REQUEST FOR COUNCIL ACTION **DATE: 2-19-03** ITEM NO. ORIGINATING DEPT: AGENDA SECTION: **PLANNING PUBLIC HEARINGS** ITEM DESCRIPTION: General Development Plan #198, by Dave & Donna Geselle Trust and PREPARED BY: Lyndon Geselle Trust - Charles Geselle Trustee to be known as Villas on the Parkway. The Brent Svenby, applicant is proposing to develop a 4.8 acre parcel of land with uses permitted in the R-2 Planner zoning district. The development would be served by public and private roadways. The property is located along the west side of West River Parkway NW, east of 4th Avenue NW February 12, 2003

RE: Geselle Property Development / West River Townhomes Traffic Summary

General Development Plan #198, by Dave & Donna Geselle Trust and Lyndon Geselle Trust - Charles Geselle Trustee to be known as Villas on the Parkway. The applicant is proposing to develop a 4.8 acre parcel of land with uses permitted in the R-2 zoning district. The development would be served by public and private roadways. The property is located along the west side of West River Parkway NW, east of 4th Avenue NW and south of 31st St.

MEMO FROM CHARLIE REITER TRANSPORTATION DIVISION

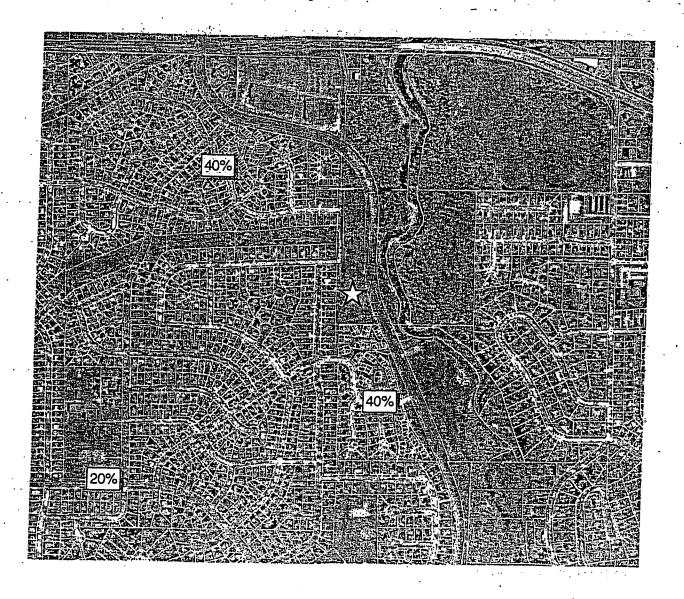
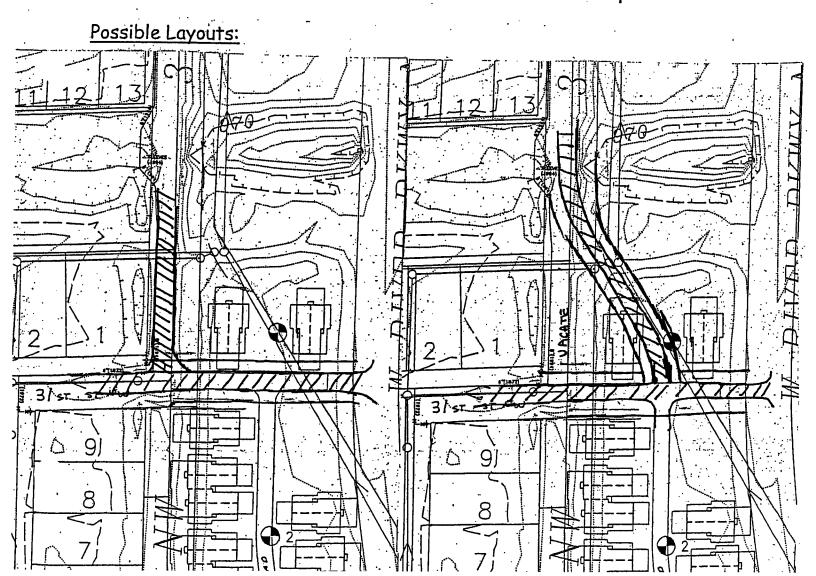
Street Design Issue - Should 31st St be extended to West River parkway?

- ·Would remove almost all of development traffic from neighborhood
- ·Spacing of intersection on West River Parkway is in good location meets desired spacing (from Zumbro Dr to south and 3^{rd} Ave to north) and appears to have good site distance
- ·Would probably pull some traffic off of Zumbro Drive and maybe a small amount off of Chalet Drive/9th Ave (primarily traffic from 31st St area)

- ·Would add traffic to eastern end of existing 31st St
- ·Would pull traffic from Chalet Drive area desiring to go south on Parkway into the area
- ·Probably would result in the loss of some units in the development
